Technical Report			
Application No:	PA23/198		
Lodgement Date:	10 March 2023		
Address:	Lot 60, 394 Robertson Road, Cardup		
Proposal:	Retrospective and Prospective Concrete Product Manufacturing Facility		
Land Use:	Industry General	Permissibility:	P as designated under the LSP
Owner:	Kandalee Pty Ltd and Mecca Holdings Pty Ltd		
Applicant:	Harley Dykstra Pty Ltd		
TPS2 Zoning:	Urban Development and Special Use	LSP Designation:	Industry General
Delegation Type:	12.1.1	Officer:	David Quelch
Site Inspection:	Yes		
Advertising:	Yes		
Internal Referrals:

Figure 1. Footprint of impacts and existing sensitive receptors within a 1500m radius of the proposed concrete manufacturing facility.

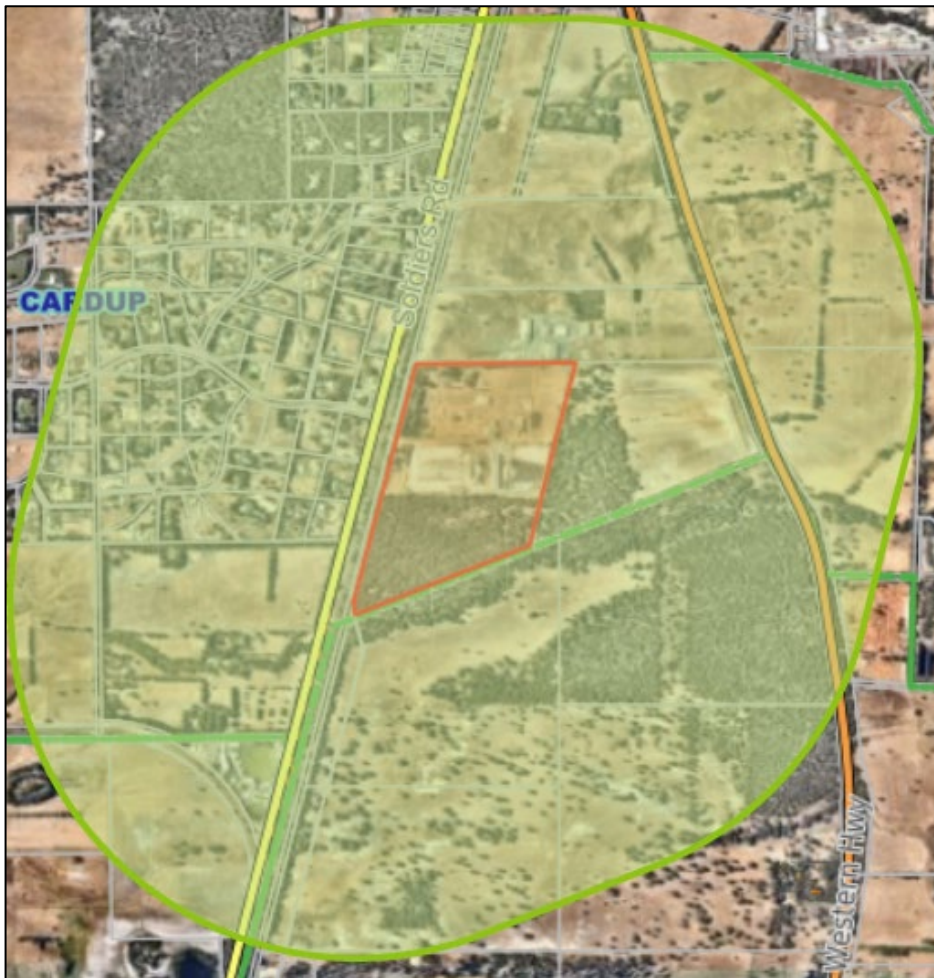
On the basis of the proposed throughput of greater than 150,000 Tonnes per annum, and giving consideration to the number of complaints received by the Shire over the course of normal existing operations, an appropriate buffer for this facility is 1,500m. Importantly, there are existing residential premises as close as 260 metres from the current hardstand footprint – indicating a known and significant risk of off-site impacts from this development.

Figure 1 shows the existing residents captured to the west of the development. In addition, consideration is given to future residents to developed to the north of Bishop Road and the extension of the Whitby Estate north into the buffer zone. The Local Structure plan for the Whitby precinct did not consider noise buffers from Permacast.

Figure 2. Extent of development under the Whitby Precinct Local Structure Plan and corresponding noise buffers to transport corridors, no consideration of Permacast emissions.

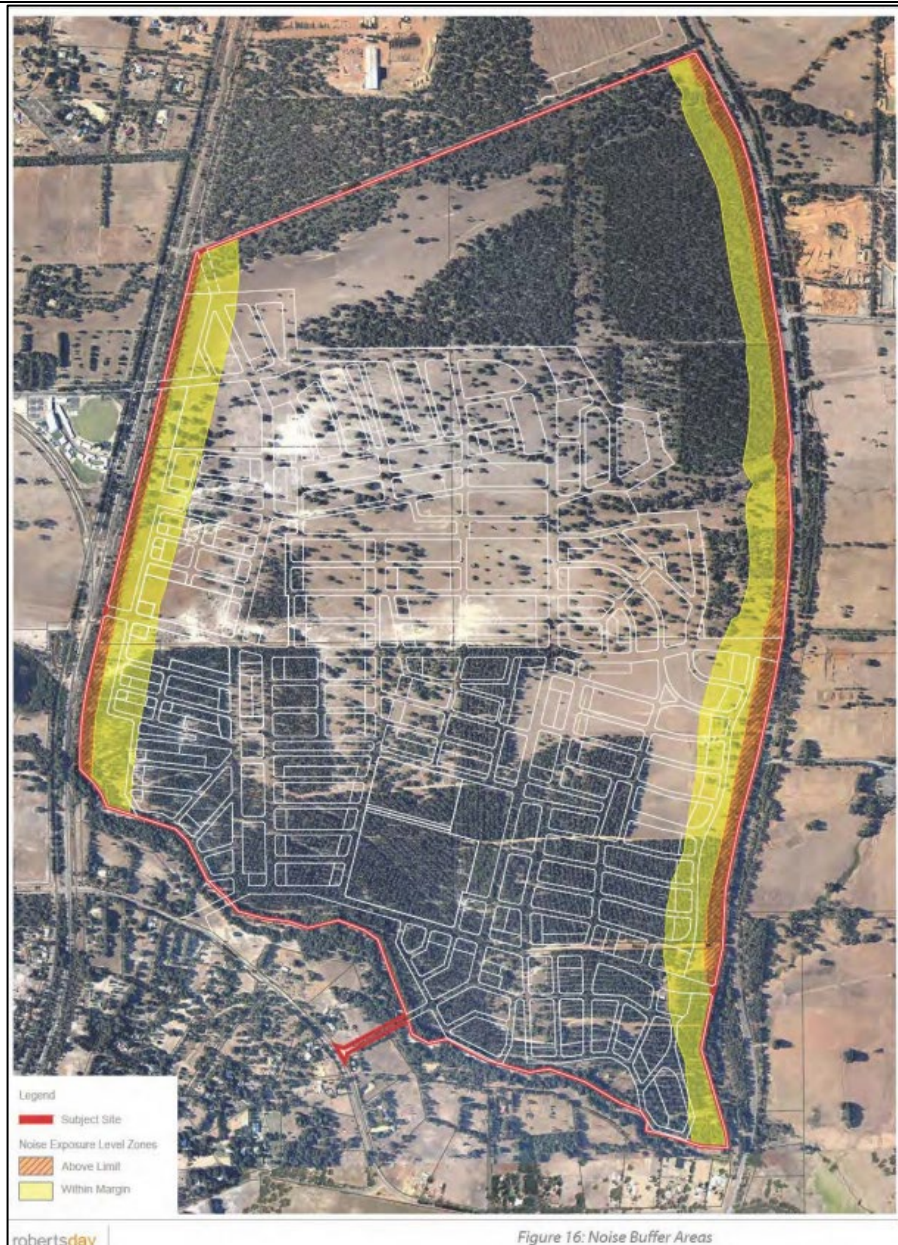
- Consideration predicted noise and vibration impacts to future sensitive receptors south of the site in the Whitby Precinct Local Structure Plan.

Below is a diagram of the recommended landscape treatments to the development.

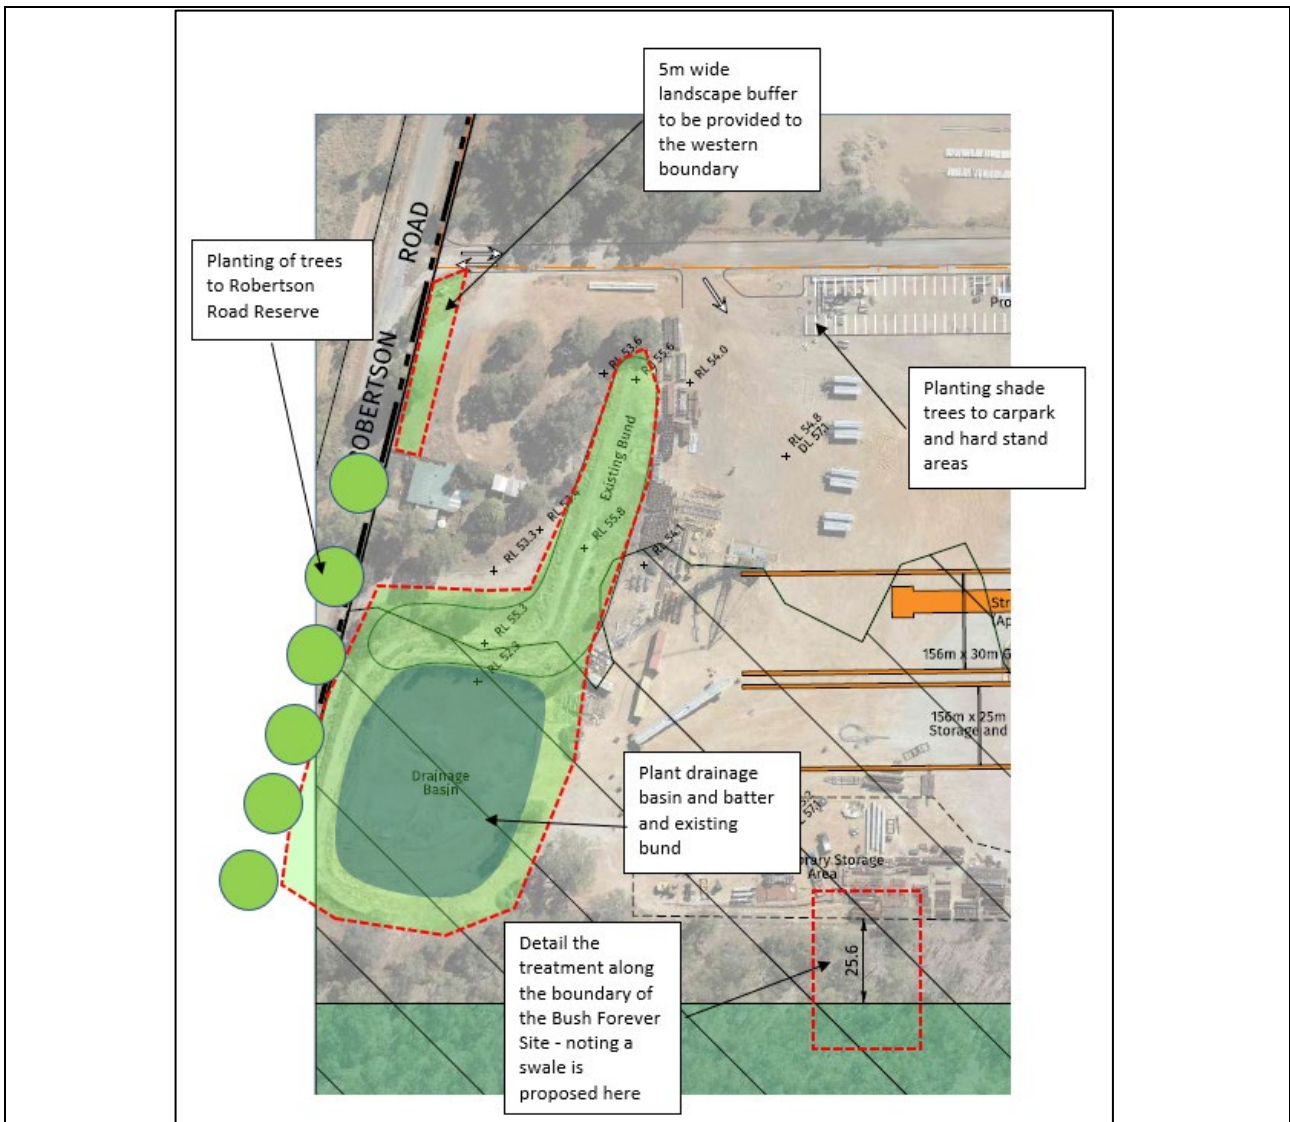
It is recommended that a 5m wide planted buffer along the western boundary is installed north of the existing office buildings, this is to screen the extensive car parking and overall development from Robertson and Soldiers Road.

Also recommended to plant the existing drainage basin, existing bund and Robertson Road reserve.

In addition, it is recommended that shade trees are planted within the carpark, this will provide shade, reduce the heat island effect, and visually soften the appearance of the extensive carpark. The carpark and hardstand areas may also have first flush treatments (first 15mm of run-off), which should be treated through planted raingardens or swales – these should also be demonstrated on a landscape plan.

Figure 12: Management Areas – includes a landscape protection area along the western boundary of lot 60, this supports the recommendation of planting along this boundary.

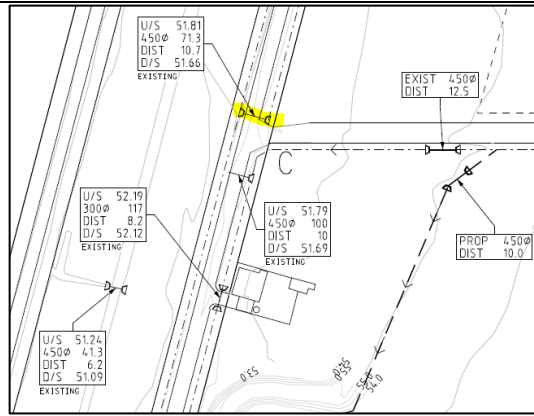
The landscape plan should confirm plant species, numbers proposed and size at the time of planting. Plant species should be native species to the area and not likely to disperse seeds/weeds into the adjoining Bush Forever Sites.

Landscaping within the interface of Bush forever sites to consist of local native flora species, preferably dieback and fire resistant species. See local flora species list in Appendix C of the Integrated Landscape Management Strategy.

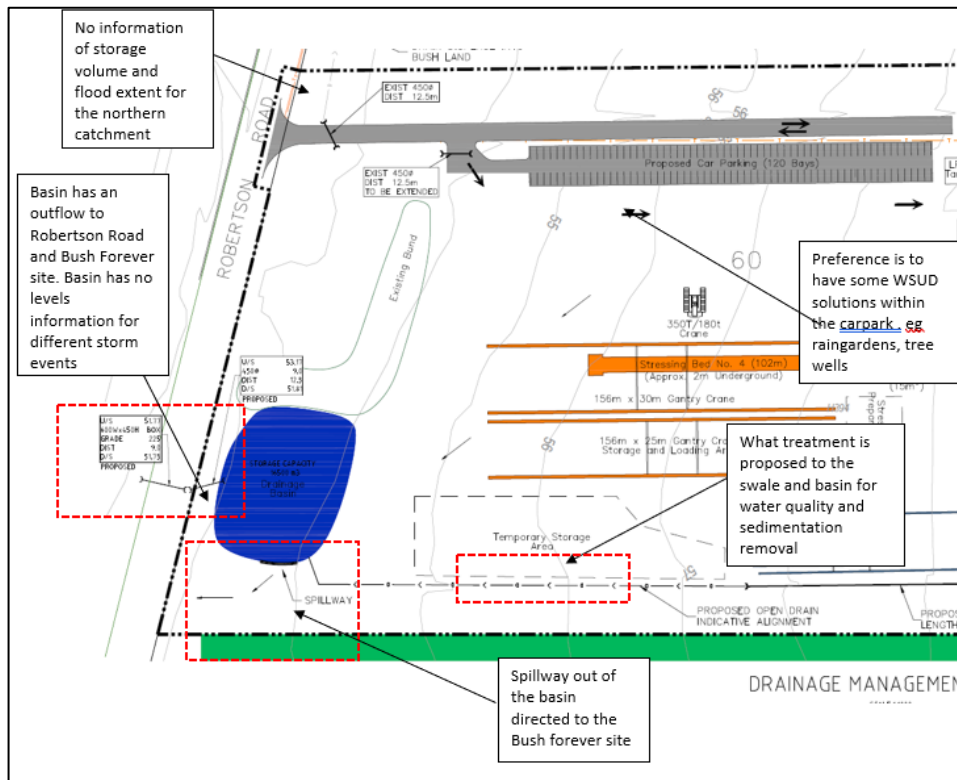
- The carpark and driveway extent of storage for all events are not clear, only showing pipe discharge north of the site. Again, provision to treat the first flush close to the source within the car park with raingardens and tree wells. It is not acceptable to simply discharge into existing bushland without treatment from a new carpark/driveway hardstand. There is an existing culvert which has been used in the past, it must be shown that drainage is not overflowed into Robertson Road.

- Report to include maintenance section to address sedimentation and required frequency of maintenance regime.
